**Re: Kirkpatrick
8610 President Place
Request Permanent C.O. - Accepted
Engineer's Stamp dated: 2-5-15 (C17D122)
Certification dated: 9-14-15**

RE: Revised Grading Plan (C-17D122)
Kirkpatrick Warehouse
Albuquerque, New Mexico

ENGINEER'S SEAL	TRACT B-1-A-5 CLIFFORD INDUSTRIAL PARK	DRAWN BY: JCG
	GRADING AND DRAINAGE PLAN	DATE: 01-12-2015
DAVID SOALE P.E. #14622	 Rio Grande Engineering 1800 CENTRAL AVENUE SE SUITE 200 ALBUQUERQUE, NM 87106 (505) 875-0000	SHEET # 1 OF 1
		JOB #

ENGINEER'S SEAL	TRACT B-1-A-5 CLIFFORD INDUSTRIAL PARK	DRAWN BY JDG
	GRADING AND DRAINAGE PLAN	DATE 01-12-2015
1/13/15	 <i>Rio Grande</i> <i>Engineering</i> 1606 CENTRAL AVENUE SE SUITE 201 ALBUQUERQUE, NM 87106 (505) 872-0999	SHEET # 1 OF 1
DAVID SOULE P.E. #14522		JOB #

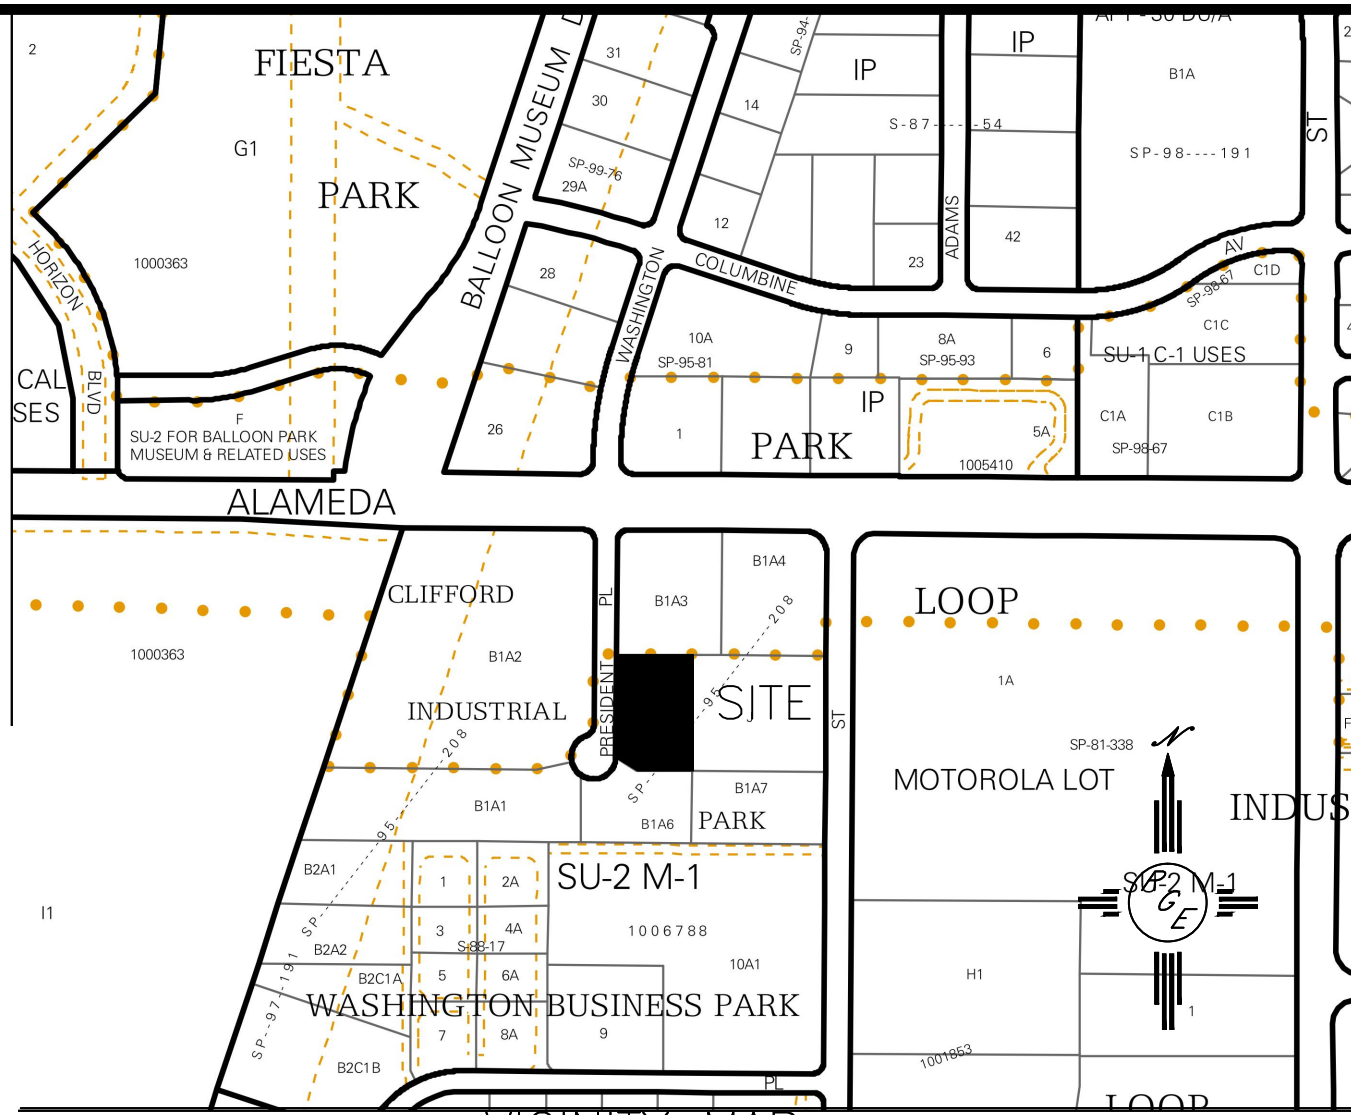
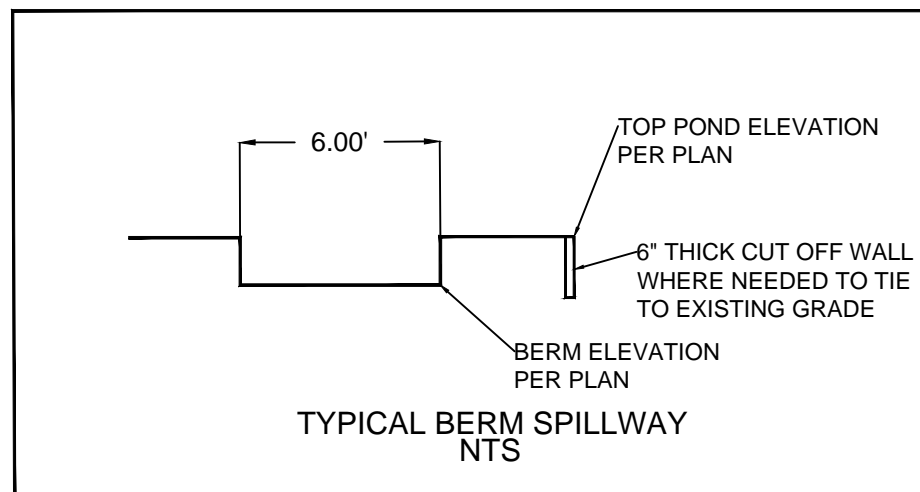
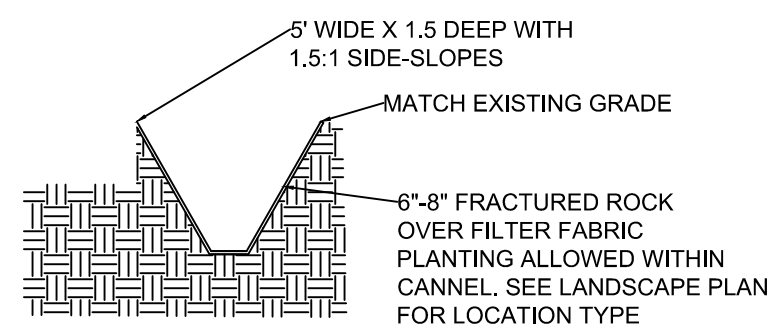
In talking with Curtis, we can only accept a volume in the rock voids of 30% not 40% that Stormtech uses. The number of units would have to be increased accordingly.

The Stormtech units can be used for retention for the First Flush. However, they cannot be used for infiltration because the DPM does not allow for infiltration at this time.

Because of these reasons, I cannot approve the Kirkpatrick plans until these issues are resolved.

The purpose of this letter is to accompany the enclosed revised grading plan. The plan has been revised to accommodate your email comments dated 1/9/15. We have chosen to forgo the Stormtech chambers in favor of a more standard ponding method. The attached plan shows the site has 3 basins. One small basin free discharges and the other two pass thru retention ponds prior to discharging. Since portions of the basin are captured by the ponds, there will be an attenuation of the peak flow. I submit that the reduction in flow rate is directly related to the ratio of total flow leaving the site compared to the total generated flow. There for Basin A retains 38% of the flow it generates therefore the peak discharge is reduced by the same 38%. This methodology is consistent with what Bernalillo County uses to calculate the attenuated peaks using retention ponds. We have preliminarily used infiltration rates from published USDA soil maps. Many Municipalities around the state allow this method. We have ordered a percolation test to confirm but would like to have plan reviewed and if acceptable have approval pending the submittal of the test. The soil type is Wink-Embudo complex with minimum 2" per hour, therefore the 3' pond will discharge in 18 hours.
